Technical Service BULLETIN

ECM CALIBRATION: SHIFT FEELING ENHANCEMENT

'04 – '05 Sienna

TC007-03

**Calibration
Identification
Chart**

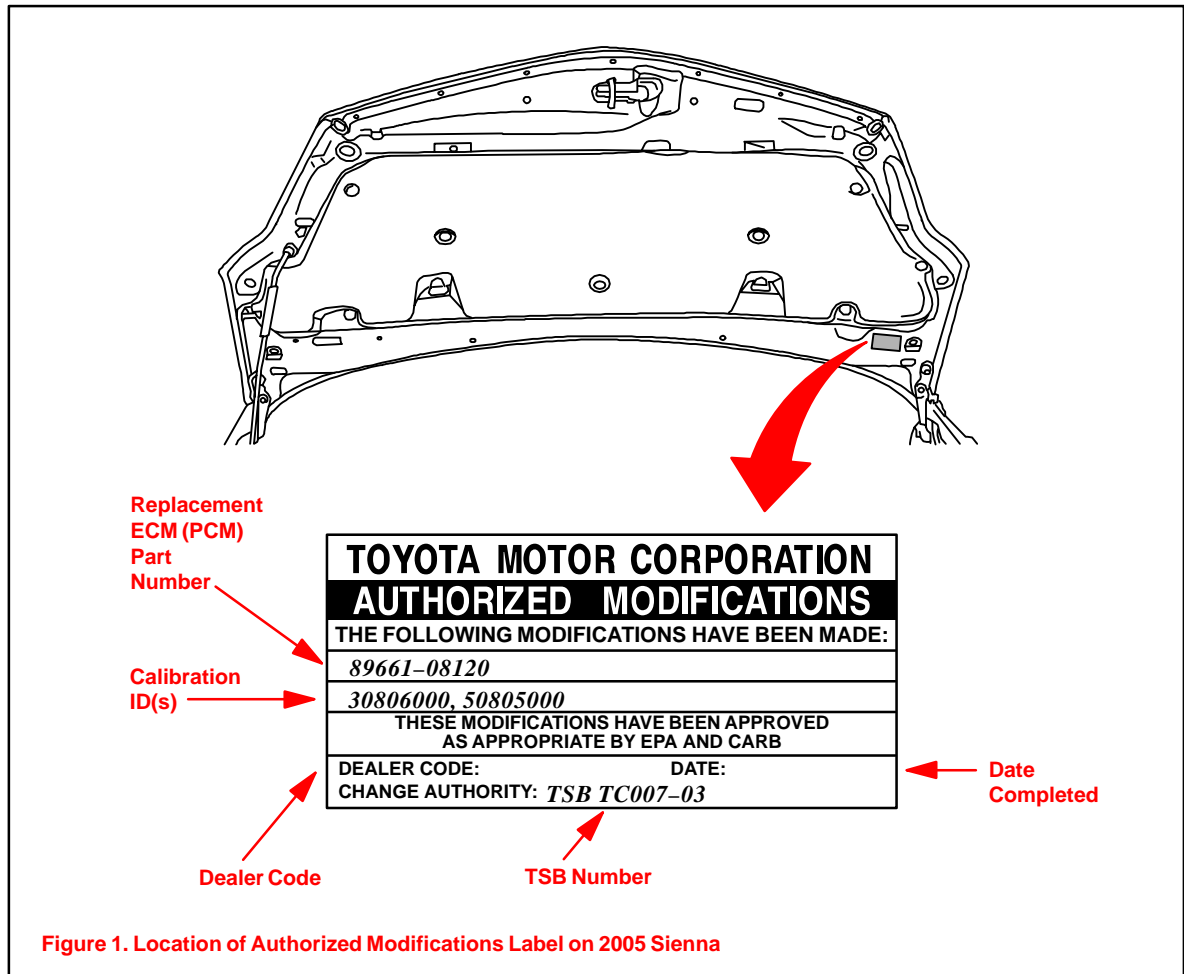
MODEL YEAR	MODEL	ECM (CPU)	PREVIOUS CALIBRATION ID	NEW CALIBRATION ID	VDS
2004 & 2005	2WD	Main	30801000 30801100 30801200 30801300 30804000	30806000	ZA22C ZA23C
		Sub	50801000 50801100 50803000	50805000	
	4WD	Main	30802000 30802100 30802200 30802300 30805000	30807000	BA22C BA23C
		Sub	50802000 50802100 50804000	50806000
